Appendices

Appendix C: Facility Reports for City Buildings and Parks

Appendix D: Facility Reports for Downtown Parking Lots

Appendix E: Public Rights-of-Way Reports for City Facilities and Schools

Grant Park Center
1575 Holt Avenue
Los Altos, CA

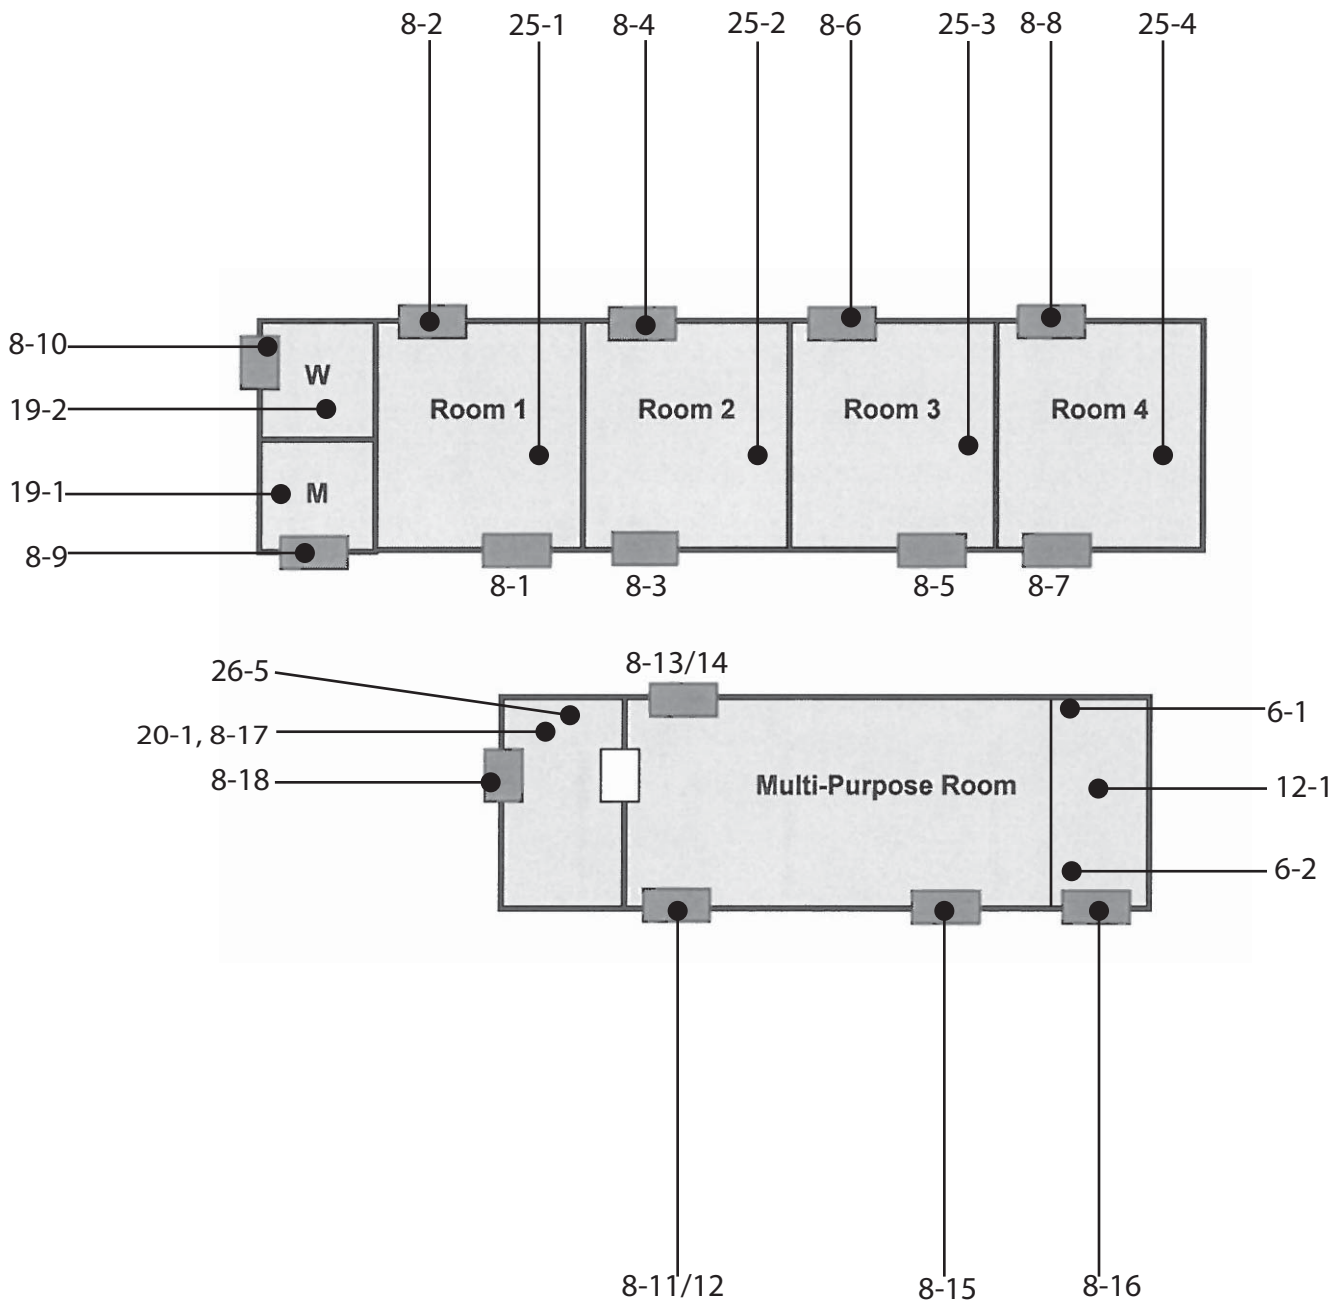
Floor 1		
6 - 1	Stairway	Priority: 1
Replace stairs		\$6,000
Notes: Stair width is 37-1/2" (44" min.) There are six risers.		
State: 1009.1		
Federal: -		
Install or modify handrails		\$5,000
Notes: Handrail is provided on one side only. Extensions are not provided on the top or bottom. Handrail is mounted 30" AFF (btwn 34-38 req.). Handrail diameter is 2" (1-1/2" req.)		
State: 1133B.4.2.1, 1133B.4.2.2, 1133B4.1.1		
Federal: 505.10.2, 505.2, 505.4		
6 - 2	Stairway	Priority: 1
Replace stairs		\$6,000
Notes: Stair width is 36" (44" min.) There are six risers.		
State: 1009.1		
Federal: -		
Install or modify handrails		\$5,000
Notes: Handrails are not provided.		
State: 1133B.4.2.1, 1133B.4.2.2, 1133B4.1.1		
Federal: 505.10.2, 505.2, 505.4		
8 - 1	Door/Gate	Priority: 1
Adjust door closer		\$250
Notes: Operating effort exceeds 5lbs.		
State: 1133B.2.5		
Federal: 404.2.9		
8 - 2	Door/Gate	Priority: 2
Provide an accessible path of travel		\$10,000

Floor 1		
8 - 3	Door/Gate	Priority: 1
Adjust door closer		\$250
Notes: Operating effort exceeds 5lbs.		
State: 1133B.2.5		
Federal: 404.2.9		
Provide or modify door kickplate		\$500
Notes: Door stop is mounted in the kick plate.		
State: 1133B.2.6		
Federal: 404.2.10		
8 - 4	Door/Gate	Priority: 2
Provide an accessible path of travel		\$10,000
Notes: Concrete pad is provided, but there is no direct path of travel to the door.		
State: ---		
Federal: 206.2.4, 404.1		
Provide or modify door kickplate		\$500
Notes: Door stop is mounted in the kick plate.		
State: 1133B.2.6		
Federal: 404.2.10		
8 - 5	Door/Gate	Priority: 1
Adjust door closer		\$250
Notes: Operating effort exceeds 5lbs.		
State: 1133B.2.5		
Federal: 404.2.9		
Provide or modify door kickplate		\$500
Notes: Door stop is mounted in the kick plate.		
State: 1133B.2.6		
Federal: 404.2.10		
8 - 6	Door/Gate	Priority: 2
Provide an accessible path of travel		\$10,000

Notes: Concrete pad is provided, but there is no direct path of travel to the door.		
State: ---		
Federal: 206.2.4, 404.1		
Provide or modify door kickplate		\$500
Notes: Door stop is mounted in the kick plate.		
State: 1133B.2.6		
Federal: 404.2.10

Floor 1		
8 - 7	Door/Gate	Priority: 1
Adjust door closer		\$250
Notes: Operating effort exceeds 5lbs.		
State: 1133B.2.5		
Federal: 404.2.9		
8 - 8	Door/Gate	Priority: 2
Provide an accessible path of travel		\$10,000
Notes: Concrete pad is provided, but there is no direct path of travel to the door.		
State: ---		
Federal: 206.2.4, 404.1		
8 - 9	Door/Gate	Priority: 2
Adjust door closer		\$250
Notes: Operating effort of Mens restroom door is 15lbs (5lbs max.)		
State: 1133B.2.5		
Federal: 404.2.9		
8 - 10	Door/Gate	Priority: 2
Adjust door closer		\$250
Notes: Operating effort of Womens restroom door is 15lbs (5lbs max.)		
State: 1133B.2.5		
Federal: 404.2.9		
Provide additional strike edge clearance		\$5,000
Notes: Strike edge clearance on the swing side of the door is 22-1/2" (24" min.)		
State: 1133B.2.4.2		
Federal: 404.2.4.1

Floor 1		
8 - 11	Door/Gate	Priority: 1
Replace or adjust door hardware		\$1,000
Notes: Panic hardware protrudes more than 4" and is mounted 37-1/2" AFF. Projections in the clear opening between 34-80" are not compliant.		
State: -		
Federal: 404.2.7		
Provide sign(s) indicating accessible entries and facilities		\$250
Notes: International Symbol of Accessibility signage is not provided.		
State: 1117B.5.8.1.2		
Federal: 216.6, 703.7.2.1		
Install or modify permanent room signs		\$250
Notes: Braille EXIT sign is not provided.		
State: -		
Federal: 1011.3		
Adjust door closer		\$250
Notes: Operating effort is 7lbs (5lbs max.)		
State: 1133B.2.5		
Federal: 404.2.9		
8 - 12	Door/Gate	Priority: 1
Replace or adjust door hardware		\$1,000
Notes: Panic hardware protrudes more than 4" and is mounted 37-1/2" AFF. Projections in the clear opening between 34-80" are not compliant.		
State: -		
Federal: 404.2.7		
Install or modify permanent room signs		\$250

Floor 1		
8 - 13	Door/Gate	Priority: 1
Replace or adjust door hardware		\$1,000
Notes: Panic hardware protrudes more than 4" and is mounted 37-1/2" AFF. Projections in the clear opening between 34-80" are not compliant.		
State: -		
Federal: 404.2.7		
Install or modify permanent room signs		\$250
Notes: Braille EXIT sign is not provided.		
State: -		
Federal: 1011.3		
8 - 14	Door/Gate	Priority: 1
Replace or adjust door hardware		\$1,000
Notes: Panic hardware protrudes more than 4" and is mounted 37-1/2" AFF. Projections in the clear opening between 34-80" are not compliant.		
State: -		
Federal: 404.2.7		
Install or modify permanent room signs		\$250
Notes: Braille EXIT sign is not provided.		
State: -		
Federal: 1011.3		
Adjust door closer		\$250
Notes: Operating effort is 7lbs (5lbs max.)		
State: 1133B.2.5		
Federal: 404.2.9

Floor 1		
8 - 15	Door/Gate	Priority: 1
Replace or adjust door hardware		\$1,000
Notes: Panic hardware protrudes more than 4" and is mounted 37-1/2" AFF. Projections in the clear opening between 34-80" are not compliant.		
State: -		
Federal: 404.2.7		
Adjust door closer		\$250
Notes: Operating effort is 9lbs (5lbs max.)		
State: 1133B.2.5		
Federal: 404.2.9		
Provide additional strike edge clearance		\$5,000
Notes: Push side of the door does not provide strike edge clearance.		
State: 1133B.2.4.2, 1133B.2.4.5		
Federal: -		
Install or modify permanent room signs		\$250
Notes: Braille EXIT sign is not provided.		
State: -		
Federal: 1011.3

Floor 1		
8 - 16	Door/Gate	Priority: 1
Replace or modify door threshold		\$1,500
Notes: Door has a threshold of 1" (1/4" max.)		
State: 1133B.2.4.1		
Federal: 404.2.5		
Replace or adjust door hardware		\$1,000
Notes: Panic hardware protrudes more than 4" and is mounted 37" AFF. Projections in the clear opening between 34-80" are not compliant.		
State: -		
Federal: 404.2.7		
Adjust door closer		\$250
Notes: Operating effort is 8lbs (5lbs max.)		
State: 1133B.2.5		
Federal: 404.2.9		
Increase or provide maneuvering or clear floor area		\$2,000
Notes: Level space on the push side of the door is 33" (48" min.)		
State: 1133B.2.4.2		
Federal: 404.2.4.1		
Provide additional strike edge clearance		\$5,000
Notes: Strike edge clearance on the push side of the door is 5" (12" min.)		
State: 1133B.2.4.2		
Federal: 404.2.4.1		
Install or modify permanent room signs		\$250
Notes: Braille EXIT sign is not provided.		
State: -

Federal: 1011.3		
8 - 17	Door/Gate	Priority: 2
Enlarge door opening		\$5,000
Notes: Single user restroom door is 28" wide (32" min.)		
State: 1133B.2.2		
Federal: 404.2.3		
Increase or provide maneuvering or clear floor area		\$2,000
Notes: Level space on the swing side of the door is 56" (60" min.)		
State: 1133B.2.4.2		
Federal: 404.2.4.1

Floor 1		
8 - 18	Door/Gate	Priority: 2
Provide sign(s) indicating accessible entries and facilities		\$1,000
Notes: Non-accessible entries should be marked with directional signage. This may be a staff only entrance.		
State: 1117B.5.8.1.2		
Federal: 216.6		
Install or modify permanent room signs		\$250
Notes: Braille EXIT sign is not provided.		
State: -		
Federal: 1011.3		
12 - 1	Building Level / Lift	Priority: 2
Install ramp or lift		\$35,000
Notes: Wheelchair lift is not provided to the stage area.		
State: 1120B.1		
Federal: 206.2.3

Floor 1		
19 - 1	Multiple User Restroom	Priority: 2
Install sign		\$500
Notes: Accessible restroom signage is not provided for the Women's restroom.		
State: 1115B.6		
Federal: 703		
Replace or reposition dispensers or mirrors		\$450
Notes: Reflecting surface of mirror is located 41" AFF; soap dispenser is located at 44" AFF; seat cover dispenser in stall is located at 56" AFF (40" max.)		
State: 1115B.8.1.1, 1115B.8.3		
Federal: 603.3		
Replace or adjust water controls		\$500
Notes: Water controls require 12lbs to operate (5lbs max.)		
State: 1115B.4.3		
Federal: 606.4		
Provide or replace stall door hardware		\$250
Notes: Loop shaped handle is provided on the front of the stall door only. (front and back req.)		
State: 1115B.3.1.4		
Federal: 604.8.1.2		
Reposition toilet flush controls		\$1,000
Notes: Flush control is not located on the wide side of the water closet.		
State: 1115B.4.1.5		
Federal: 604.6		
Replace or modify grab bars		\$1,000

Notes: Rear grab bar is extends 12" from the centerline of the water closet (compliant) and 22" on the other side (24" min.). Side grab bar is located 23" in front of the water closet (24" min.) Entire length of grab bar from back of the wall is 51" (54" min.)		
State: 1115B.4.1.3		
Federal: 604.5.1		
Increase or provide maneuvering or clear floor area		\$2,000
Notes: Clear space of 36-1/2" is provided throughout the restroom (44" min.)		
State: 1115B.3.1.4.5		
Federal: -		
Reposition controls and outlets		\$2,000
Notes: Light switch requires grasping and twisting.		
State: -		
Federal: 305

Floor 1		
19 - 2	Multiple User Restroom	Priority: 2
Install sign		\$500
Notes: Accessible restroom signage is not provided for the Men's restroom.		
State: 1115B.6		
Federal: 703		
Replace or reposition dispensers or mirrors		\$450
Notes: Reflecting surface of mirror is located 42" AFF; soap dispenser is located at 44" AFF; seat cover dispenser in stall is located at 57" AFF (40" max.)		
State: 1115B.8.1.1, 1115B.8.3		
Federal: 603.3		
Replace or adjust water controls		\$500
Notes: Water controls require 17lbs to operate (5lbs max.)		
State: 1115B.4.3		
Federal: 606.4		
Provide or replace stall door hardware		\$250
Notes: Loop shaped handle is provided on the front of the stall door only. (front and back req.)		
State: 1115B.3.1.4		
Federal: 604.8.1.2		
Replace or modify grab bars		\$1,000
Notes: Side grab bar is located 19" in front of the water closet (24" min.) Entire length of grab bar from back of the wall is 51" (54" min.)

State:	1117B.9	
Federal:	-	
Replace or reposition dispensers or mirrors		\$150
Notes:	Paper towel dispenser is located at 48" AFF (40" max.)	
State:	-	
Federal:	308	
Replace or adjust water controls		\$500
Notes:	Water controls require grasping and twisting.	
State:	1117B.9	
Federal:	309

Notes: Paper towel dispenser is located 48" AFF; soap is located 46" AFF (40" max.)		
State: -		
Federal: 308

Hillview Community Center
97 Hillview Avenue
Los Altos, CA

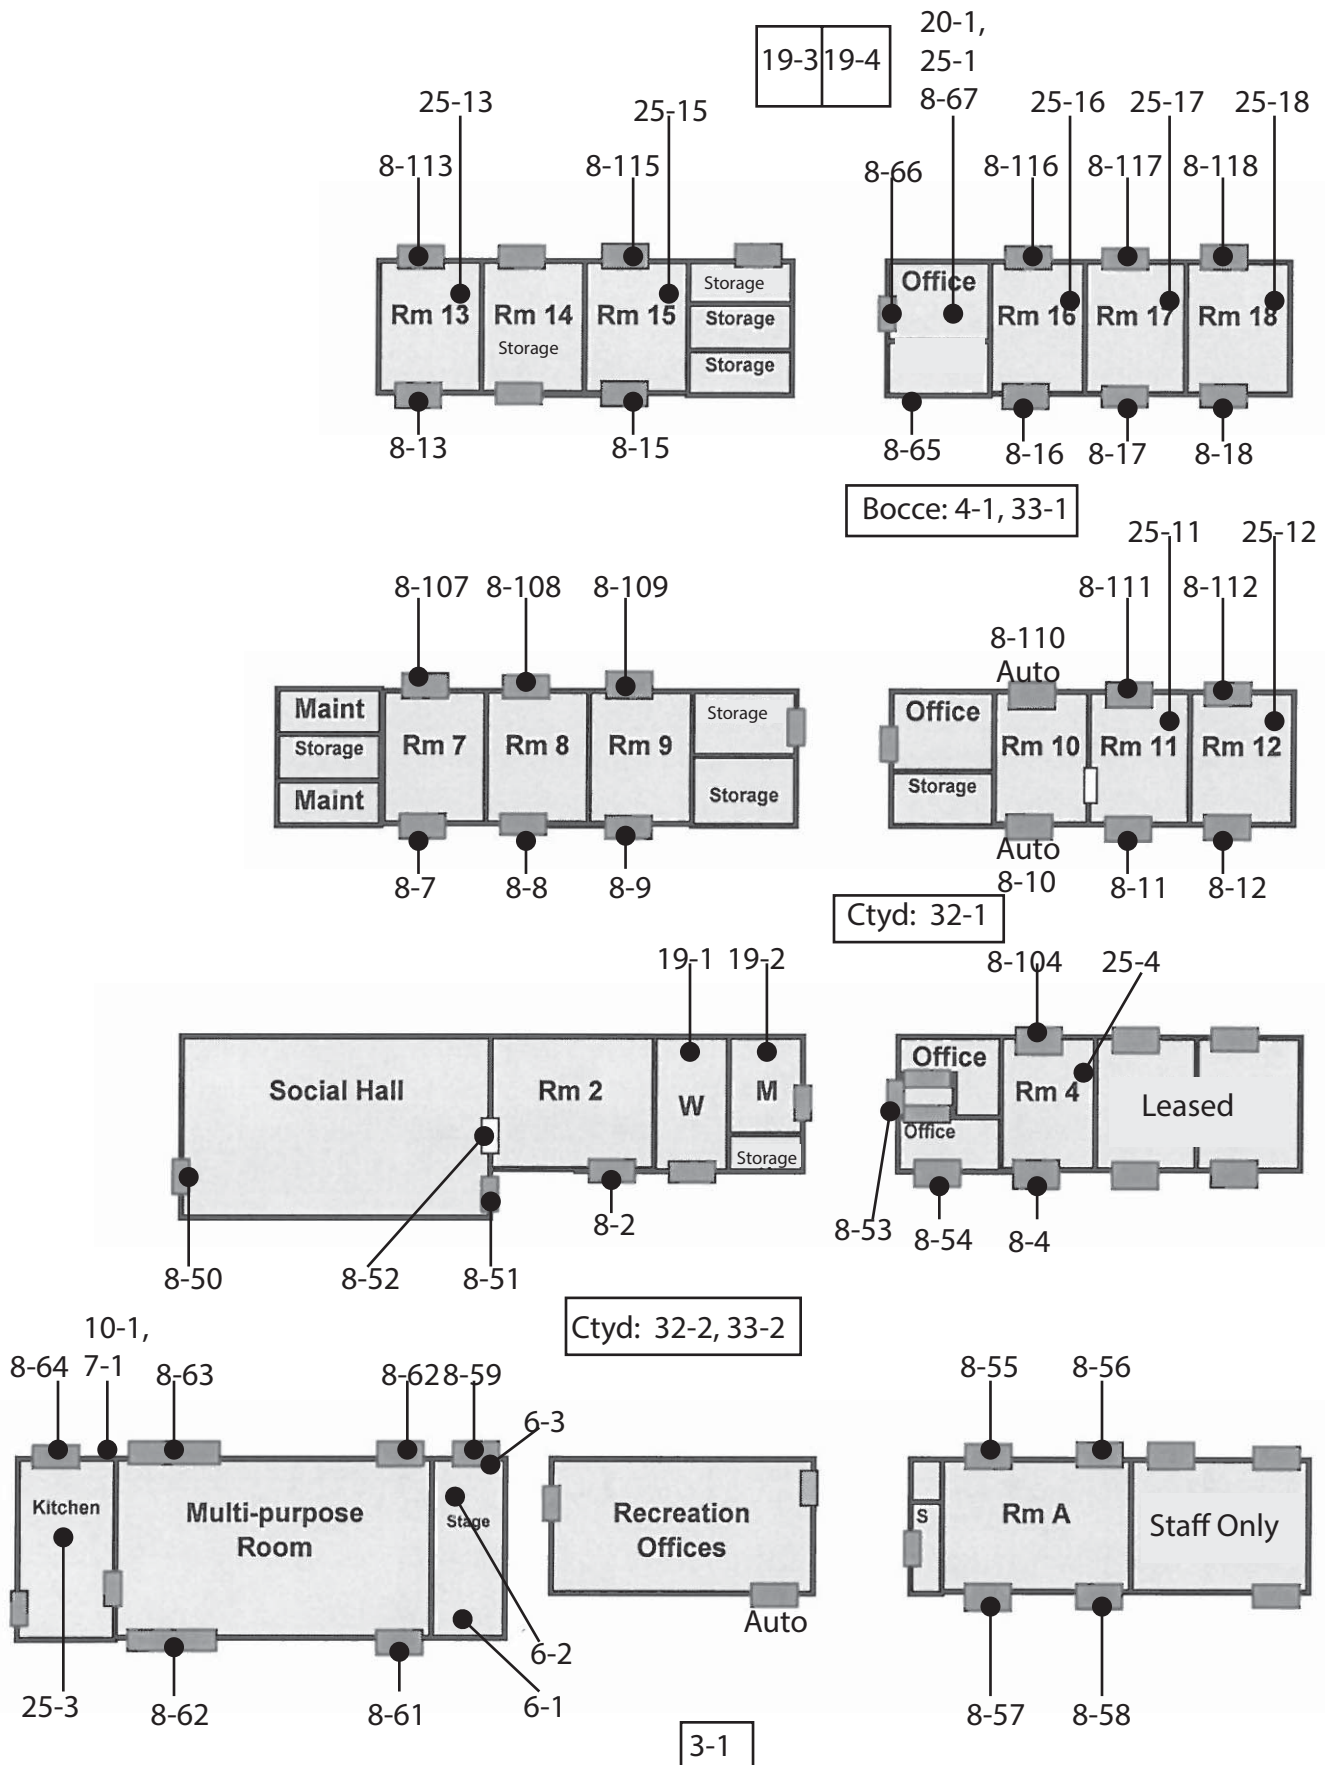
Exterior		
3 - 1	Curb Ramp	Priority: 1
Provide detectable warning strip		\$1,000
Notes: Truncated domes are not provided on the curb ramp.		
State: 1127B.5.7		
Federal: -		
Install, replace or modify curb ramp		\$3,500
Notes: Slope of flared sides exceed 10%.		
State: 1127B.5.3, 1127B.5.4		
Federal: 406.3		
4 - 1	Walk	Priority: 3
Regrade surface		\$500
Notes: Slope to bocce ball area is 7.1%. 5ft.		
State: 1133B.7.3		
Federal: 403.3		
7 - 1	Hazard	Priority: 1
Remove overhanging or protruding objects		\$1,000
Notes: Drinking fountain is located in the path of travel and protrudes 14" (4" max.) and is located 25" AFF (below 27", above 80" req.)		
State: 1133B.8.6		
Federal: 307.2		
10 - 1	Drinking Fountain	Priority: 3
Adjust water stream		\$100
Notes: Controls require grasping and twisting.		
State: 1117B.6.4		
Federal: 309		
Replace or reposition drinking fountain		\$5,000
Notes: Fountain depth is 14" (18-19" req.)

Replace or reposition dispensers or mirrors		\$300
Notes: Reflecting surface of mirror is 47-1/2" AFF; paper towel dispenser is 54" AFF (40" max.)		
State: -		
Federal: 308		
Modify lavatory/counter clearances		\$2,500
Notes: Knee space is not provided under the sink.		
State: 1117B.9		
Federal: -

History House
 One North San Antonio Road
 Los Altos, CA

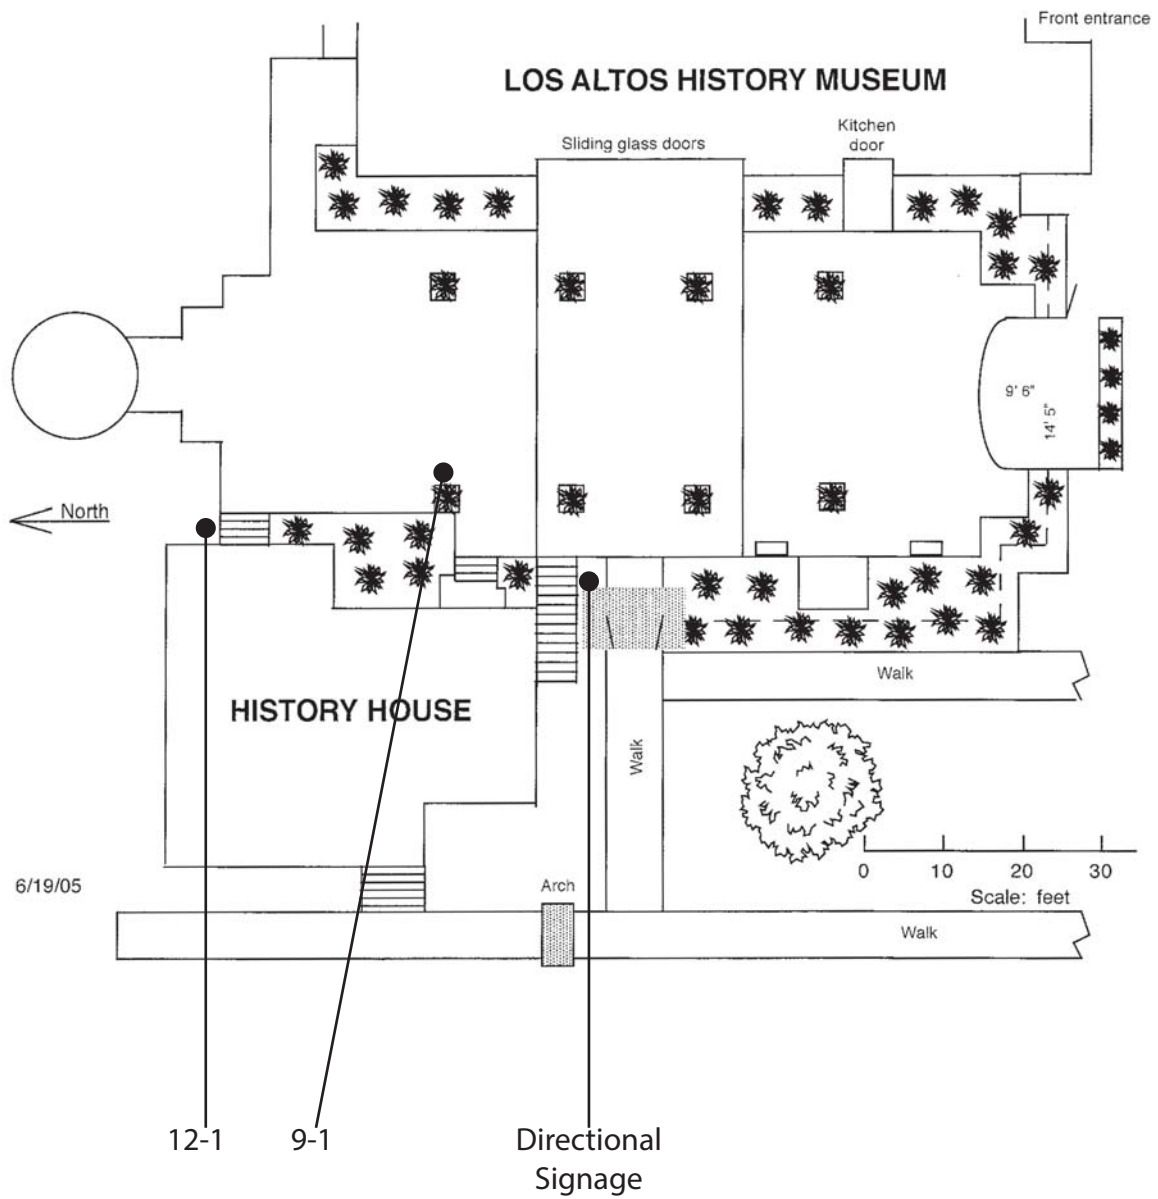
Exterior		
9 - 1	Sign	Priority: 1
Provide sign(s) indicating accessible entries and facilities		\$1,000
Notes:	Directional signage is not provided in brick patio area to guide user to the wheelchair lift.	
State:	1117B.5.8.1.3	
Federal:	-	
12 - 1	Building Level / Lift	Priority: 1
Modify or replace wheelchair lift		\$500
Notes:	"No Freight" signage is not provided on the wheelchair lift to the History House. Staff will provide photo book of interior upon request.	
State:	1116B.2.7	
Federal:	-

History Museum
Exterior, Basement and Floor One
One North San Antonio Road
Los Altos, CA

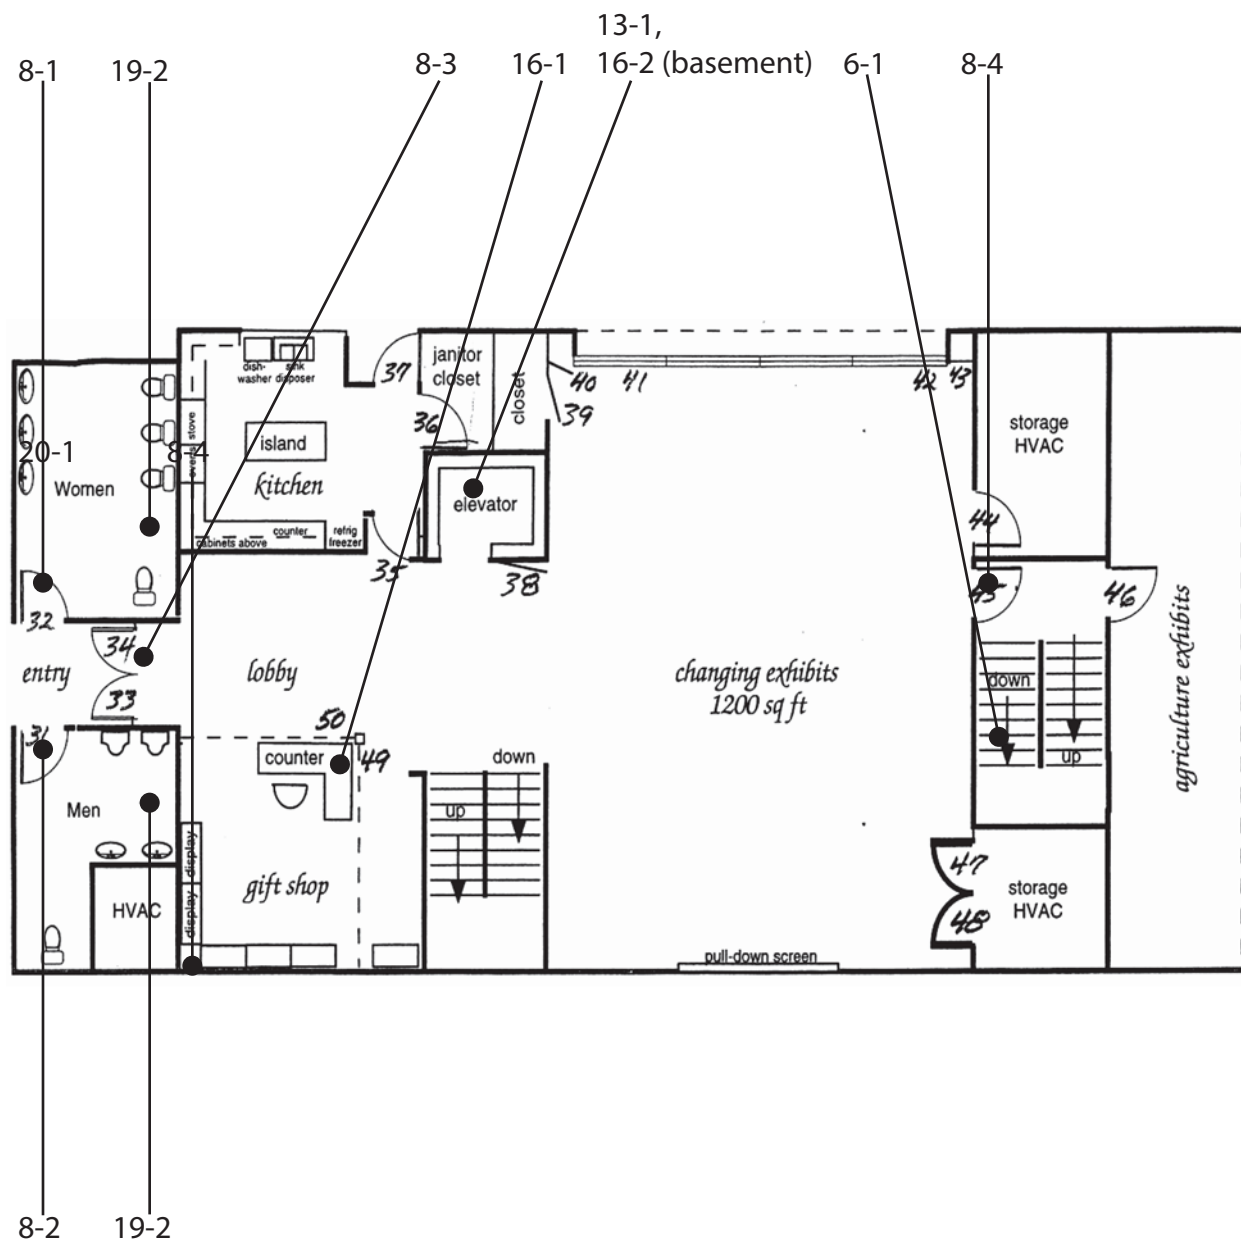
Basement		
16 - 1	Built-in Elements	Priority: 2
Provide an accessible counter		\$5,000
Notes: Counter height is 36" (btwn. 28-34" req.)		
State: 1122B.4		
Federal: -

Floor 1		
16 - 2	Built-in Elements	Priority: 2
Provide an accessible counter		\$5,000
Notes: Gift shop counter is located 38-1/2" AFF (btwn 28-34" req.)		
State: 1122B.4		
Federal: -
